SUBJECT: ISSUANCE OF AMENDMENT (TAC NO. M90035)

The Commission has issued the enclosed Amendment No. 99 to Facility Operating License No. NPF-49 for the Millstone Nuclear Power Station, Unit No. 3, in response to your application dated July 22, 1994.

AMENDMENT TO FACILITY OPERATING LICENSE

Amendment No. 99  
License No. NPF-49

RCS CRITICAL BORON CONCENTRATION (ppm)  
FIGURE 3.1-5  
REQUIRED SHUTDOWN MARGIN FOR MODE 5 WITH RCS LOOPS NOT FILLED

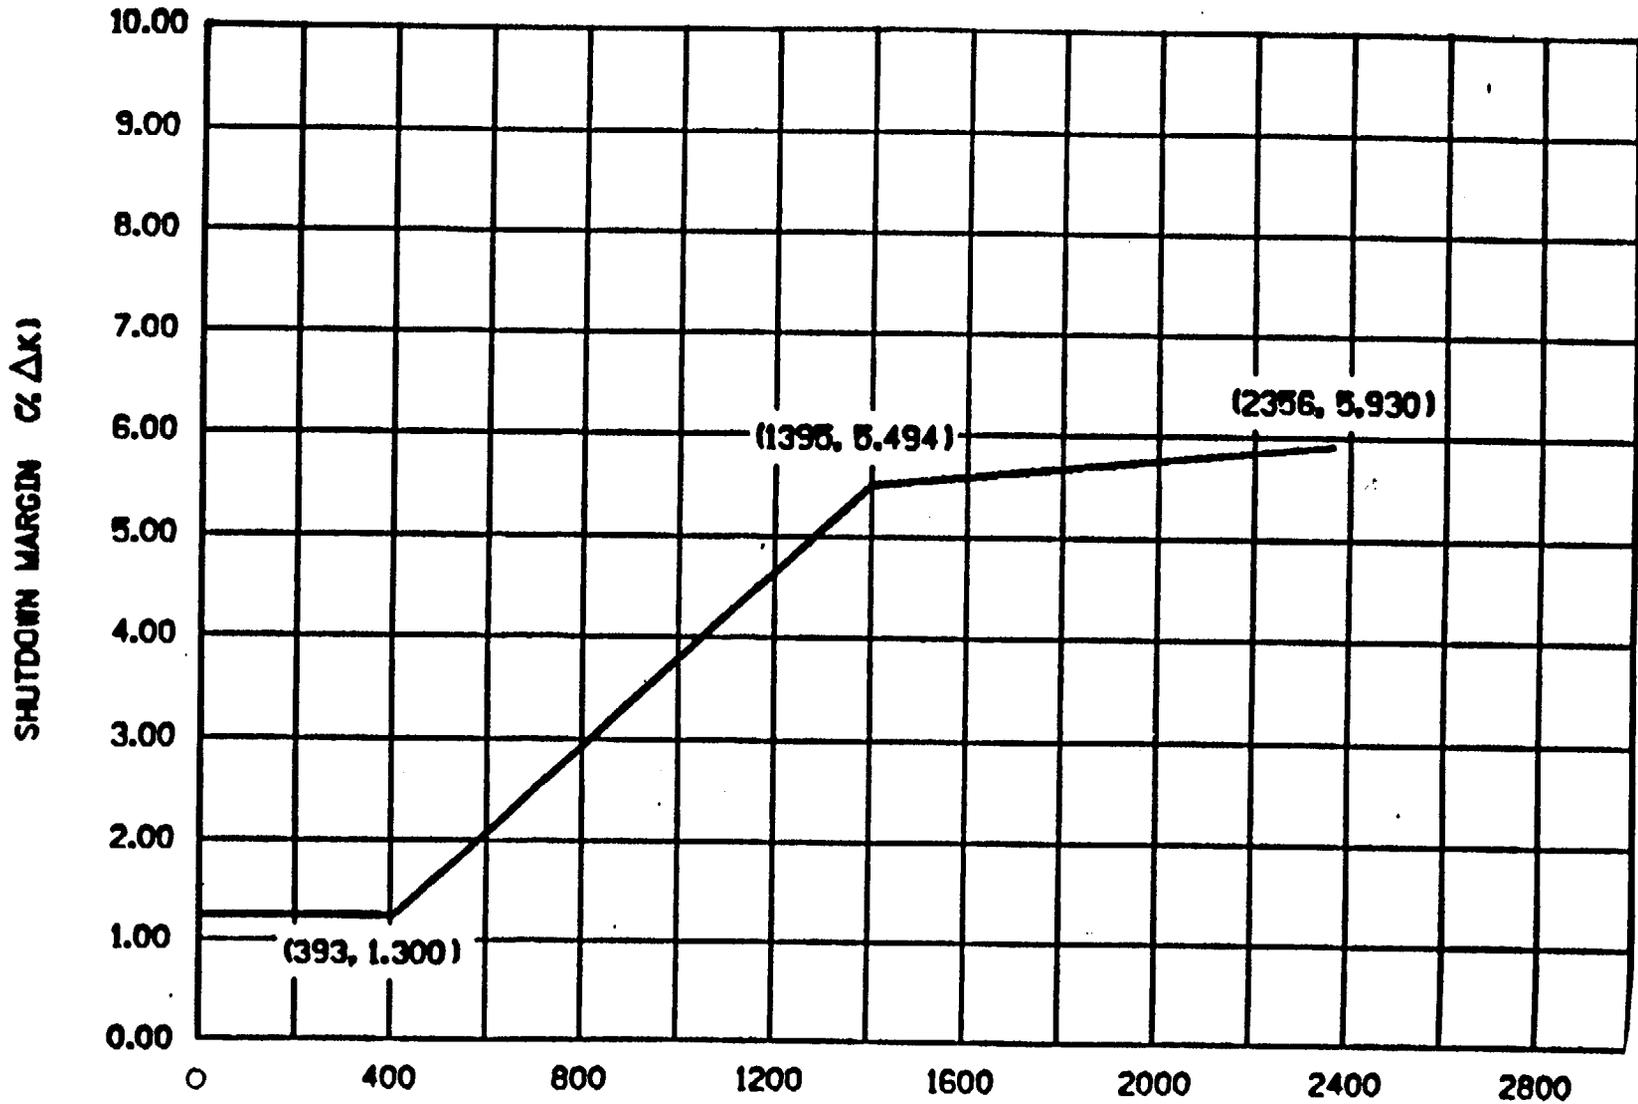
The amendment (1) changes the title of Figure 3.1-5 to be consistent with the applicable Limiting Condition For Operation (LCO), (2) relocates the Chemical and Volume Control System (CVCS) valve position requirements to the Reactivity Control Systems - Shutdown Margin specifications, and (3) consolidates action statements to be expressed in the LCOs rather than in Surveillance Requirements. The amendment also clarifies the requirements for calculating the heat flux hot channel factor  $F_q(z)$  when using the base load option.

The licensee proposed to change the title of Figure 3.1-5, "Required Shutdown Margin for Mode 5 with RCS Loops Drained." The LCO in Section 3.1.1.2 applies to "loops not filled" and refers the reader to Figure 3.1.1.2. In order to establish continuity between the two items, the words "loops drained" in the title of Figure 3.1-5 are being changed to "loops not filled" as specified in its associated LCO in Section 3.1.1.2.

- a) the limits shown in Figure 3.1-5 or
- b) the limits shown in Figure 3.1-4, with the chemical and volume control system (CVCS) aligned to preclude reactor coolant system boron concentration reduction.
